PIC18F86J72/87J72 Silicon Errata and Data Sheet Clarification

The PIC18F86J72/87J72 devices that you have received conform functionally to the current Device Data Sheet (DS39979A) except for the anomalies described in this document.

The following typographic corrections and clarifications are to be noted for the latest version of the device data sheet (DS39979A).

FIGURE 2-3 FREQUENCY vs. ESR PERFORMANCE FOR SUGGESTED VCAP

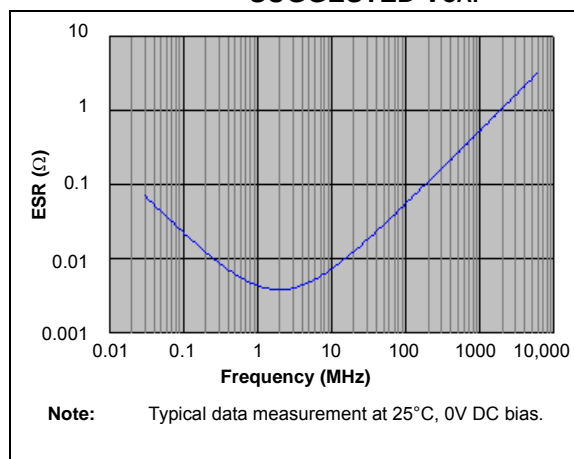
Section 2.4 Voltage Regulator Pins (ENVREG and VCAP/VDDCORE) has been replaced with a new and more detailed section. The entire text follows:

When the regulator is enabled, a low-ESR (< 5Ω) capacitor is required on the VCAP/VDDCORE pin to stabilize the voltage regulator output voltage. The VCAP/VDDCORE pin must not be connected to VDD and must use a capacitor of 10 μF connected to ground. The type can be ceramic or tantalum. Suitable examples of capacitors are shown in [Table 2-1](#). Capacitors with equivalent specifications can be used.

Designers may use [Figure 2-3](#) to evaluate ESR equivalence of candidate devices.

FIGURE 2-4 DC BIAS VOLTAGE vs. CAPACITANCE CHARACTERISTICS

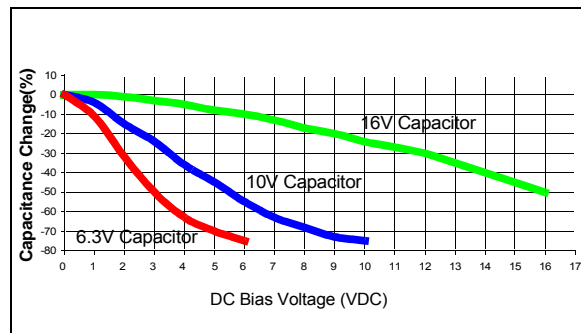
In addition to temperature tolerance, the effective capacitance of large value ceramic capacitors can vary substantially, based on the amount of DC voltage applied to the capacitor. This effect can be very significant, but is often overlooked or is not always documented.

A typical DC bias voltage vs. capacitance graph for 16V, 10V and 6.3V rated capacitors is shown in Figure 2-4.

When selecting a ceramic capacitor to be used with the internal voltage regulator, it is suggested to select a high-voltage rating, so that the operating voltage is a small percentage of the maximum rated capacitor voltage. For example, choose a ceramic capacitor rated at 16V for the 2.5V core voltage. Suggested capacitors are shown in Table 2-1.
